Project	<b>IEEE 802.16 Broadband Wireless Access Working Group</b> < <a href="http://ieee802.org/16">http://ieee802.org/16</a> >	
Title	<b>Sub-carrier Alignment for IEEE 802.16m Multi-band Frame Structure</b>	
Date Submitted	<b>2008-03-10</b>	
Source(s)	I-Kang Fu, Pei-Kai Liao, Paul Cheng, Ting-Chang Huang, Chung-Yen Wu MediaTek Inc. No.1, Dusing Rd. 1, Hsinchu Science Park, Hsin-Chu, Taiwan 30078, R.O.C.	<a href="mailto:IK.Fu@mediatek.com">IK.Fu@mediatek.com</a> <a href="mailto:pk.liao@mediatek.com">pk.liao@mediatek.com</a>
Re:	Call for Comments on C802.16m-08/118r1 by TGM Frame Structure Rapporteur Group	
Abstract	This contribution investigates the sub-carrier misalignment problem when multi-band frame structure is used in IEEE 802.16m. A simple method by adjusting RF center frequency and a supporting frequency offset estimation/reporting mechanism is provided for TGM discussion.	
Purpose	Adopt the proposed text into TGM Frame Structure Rapporteur Group baseline document

# Sub-carrier Alignment for IEEE 802.16m Multi-band Frame Structure

Figure x Sub-carrier alignment for multicarrier frame structure

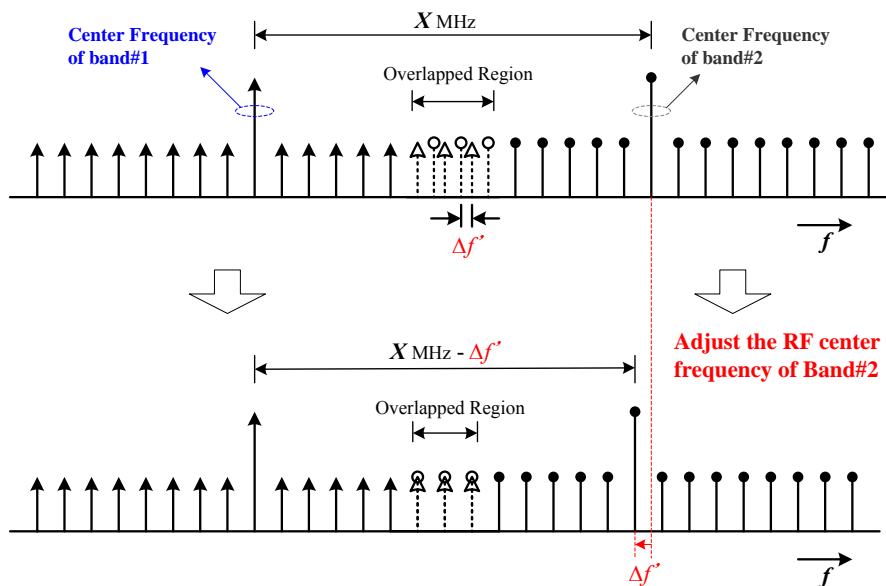
[Add the following text after line#15, page#19 of C802.16m-08/118r1]

When IEEE 802.16m multicarrier frame structure operates in single contiguous band with multiple RF carriers, part of the sub-carriers of adjacent frequency bands will be overlapped in a frequency region. In order to utilize these sub-carriers for data transmission, these sub-carriers shall be well aligned to prevent inter-carrier interference (ICI). The subcarrier alignment procedure is described as following:

1. The transmitter transmits a reference signal over the sub-carriers of Band#2 in the overlapped region
2. The receiver estimates the frequency offset ( $\Delta f'$ ) of the reference signal on Band#1
3. The receiver reports the frequency offset via the MAC message to transmitter
4. The transmitter adjusts its RF center frequency based on the reported frequency offset to achieve sub-carrier alignment, which is shown as figure x.
